Service Bulletin

Fuselage - Primary Structure, Center-Mid Fuselage - Routing Modification of the VFG Power-Feeder Harnesses

BD500-534101
Issue No. 008

Fuselage - Primary Structure, Center-Mid Fuselage - Routing Modification of the VFG Power-Feeder Harnesses - Service Bulletin

Figure 6 Right side - Routing modification of the power-feeder harnesses - Installation - (Sheet 1 of 2)

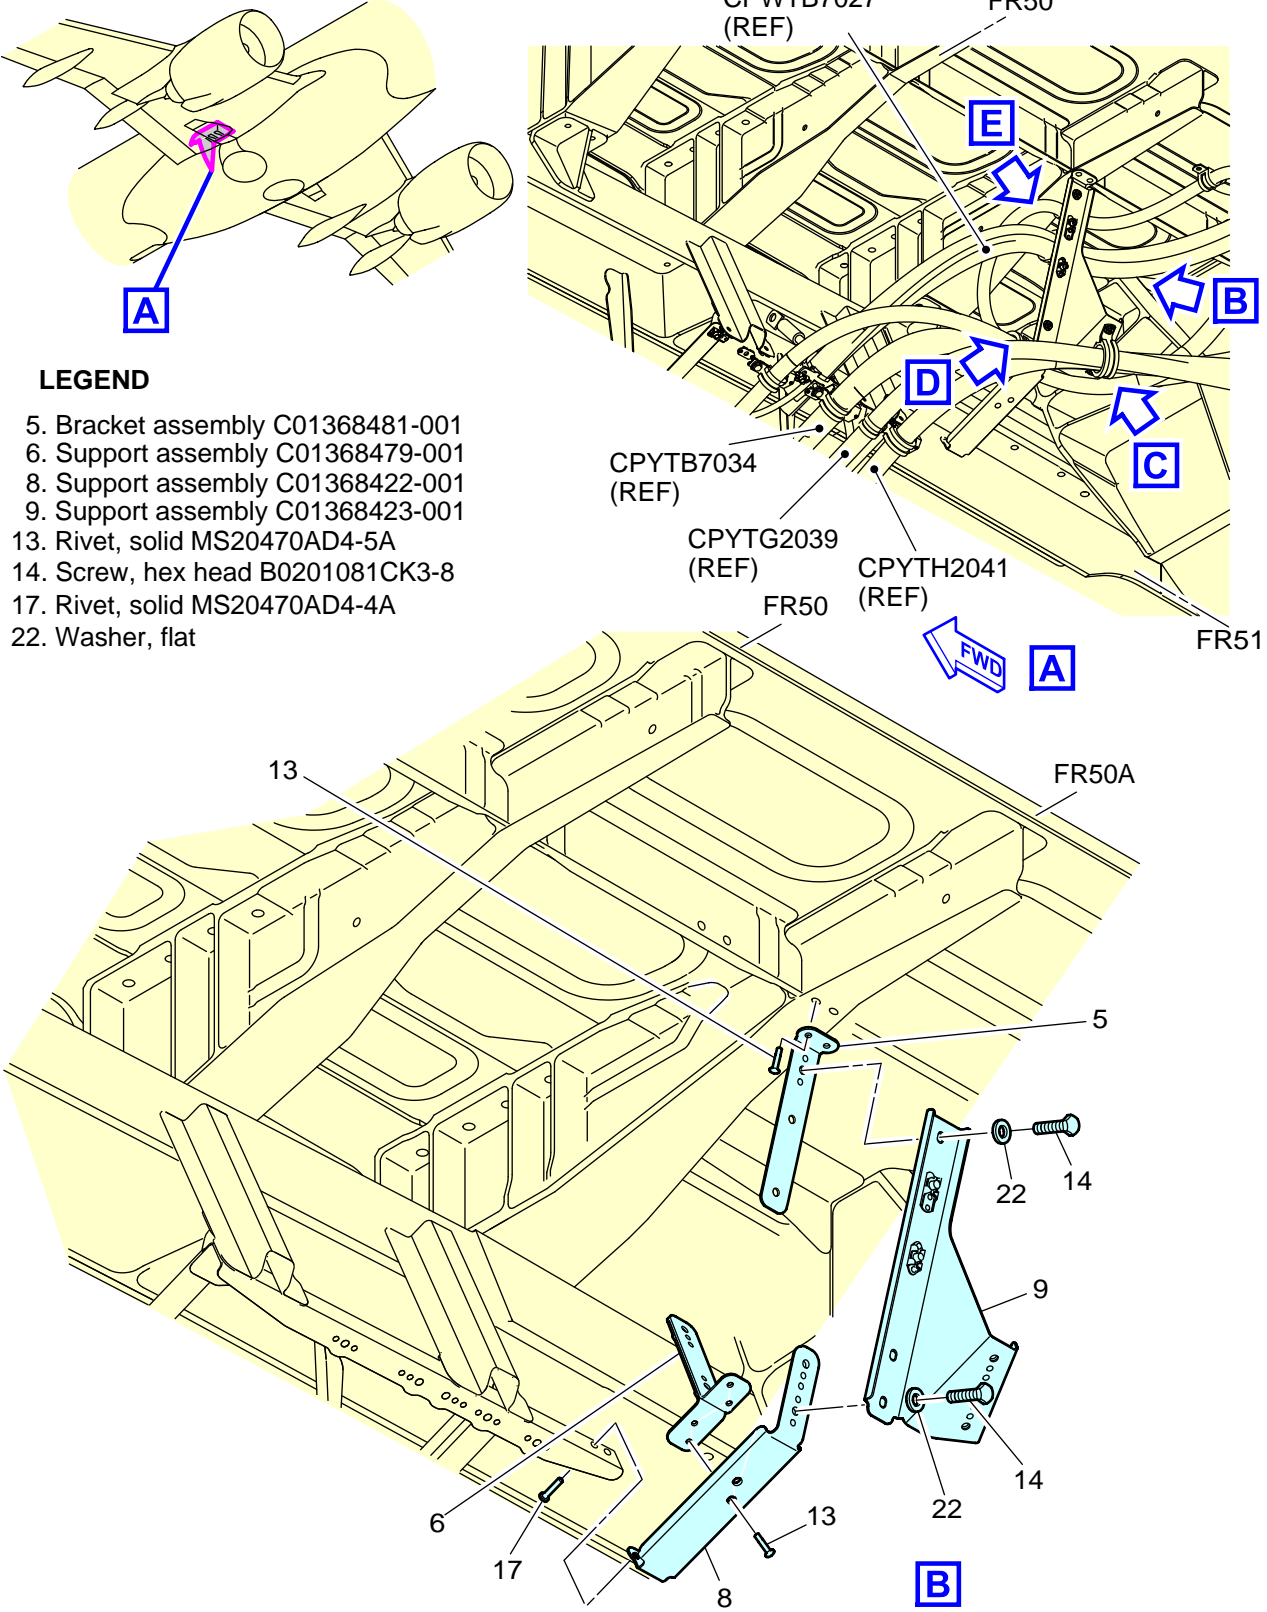
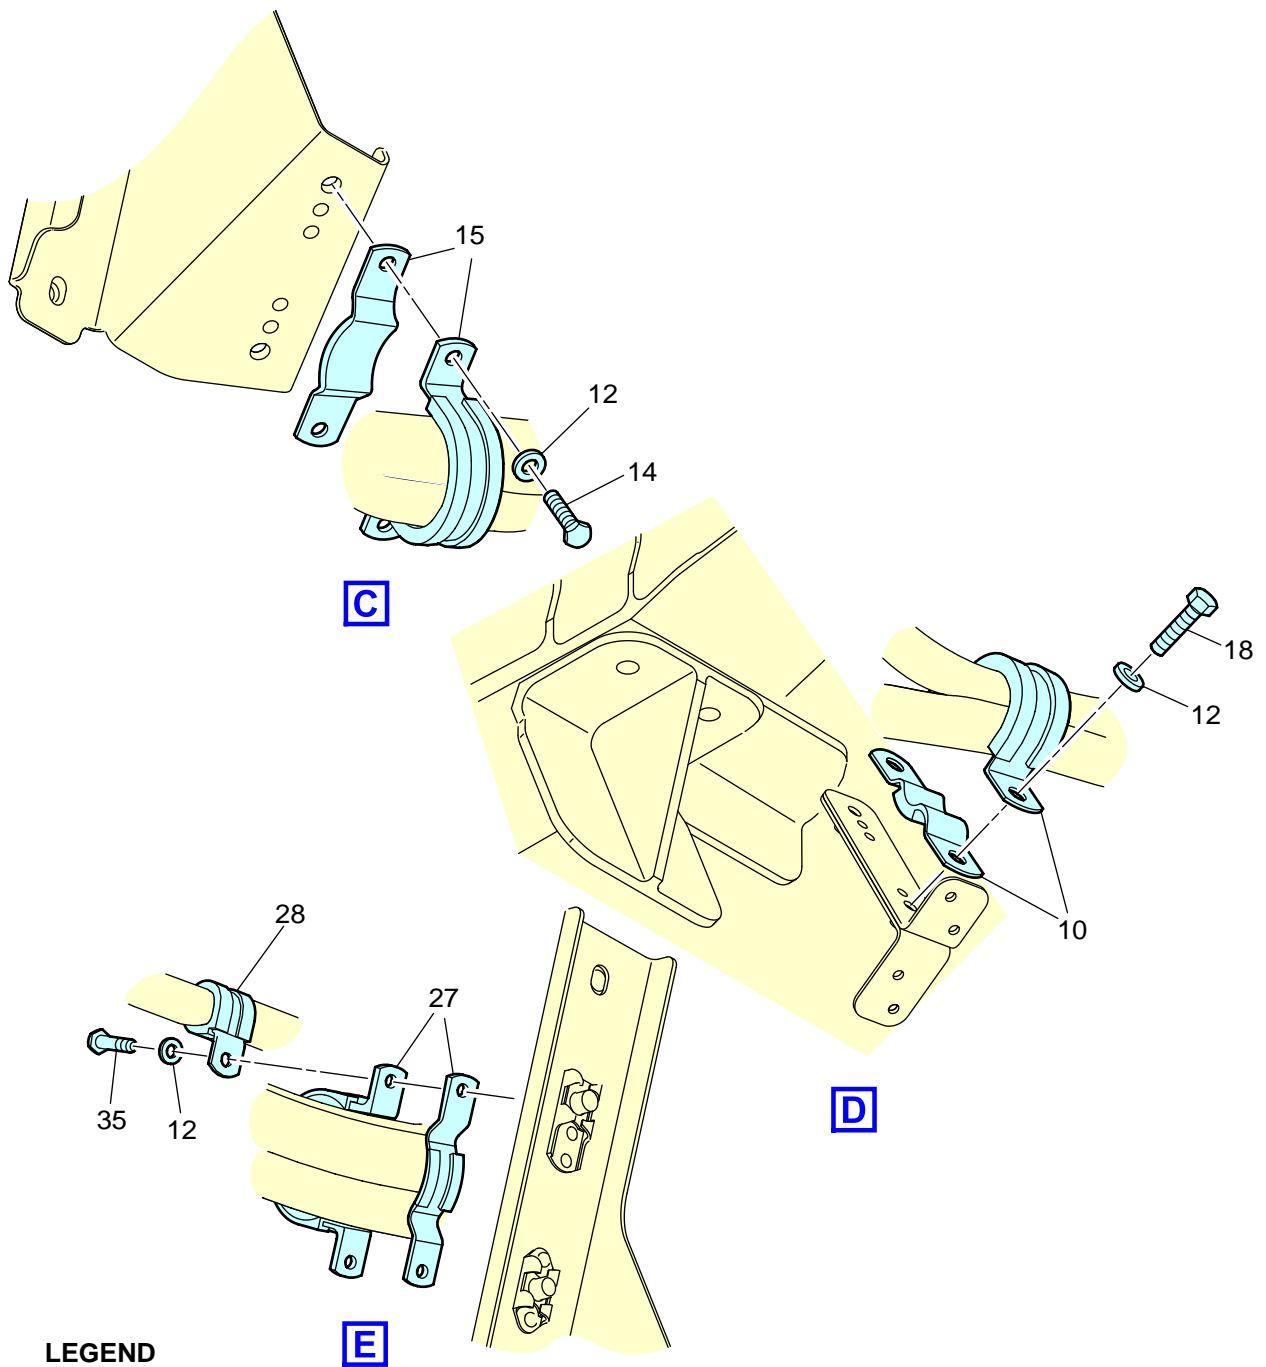
3.7.1.3 Remove the electrical system bracket assembly (5).

3.7.1.4 Remove burrs and sharp edges on the electrical system bracket assembly (5) and FR50A.

3.7.2.3 Remove the electrical system support assembly (8).

3.7.2.4 Remove burrs and sharp edges on the electrical system support assembly (8) and the electrical system bracket installation.

3.7.2.5 Wet-install with sealant the electrical system support assembly (8) on FR50A with two rivets (17) (refer to ASRP BD500-A-J51-42-06-00AAA-078A-A and ASRP BD500-A-J51-23-00-05AAA-259B-A).

3.7.2.6 Apply a layer of fluid-resistant polyurethane topcoat to the rivets (17) to agree with the color of the adjacent area (refer to ASRP BD500-A-J51-25-16-00AAA-257A-A).

-
- 3.7.3 Install the electrical system support assembly (6) as follows:
 - 3.7.3.1 Temporarily install the electrical system support assembly (6) in the using the pilot holes on the support assembly (8).

- 3.7.3.2 Open four holes in the electrical system support assembly (6) to a diameter of between 0.128 (3.25 mm) and 0.132 in. (3.35 mm) (refer to ASRP BD500-A-J51-40-11-01AAA-652A-A).

- 3.7.3.3 Remove the electrical system support assembly (6).
 - 3.7.3.4 Remove burrs and sharp edges on the electrical system support assembly (6).
 - 3.7.3.5 Wet-install with sealant the electrical system support assembly (6) on the support assembly (8) with four rivets (13) (refer to ASRP BD500-A-J51-42-06-00AAA-078A-A and ASRP BD500-A-J51-23-00-05AAA-259B-A).
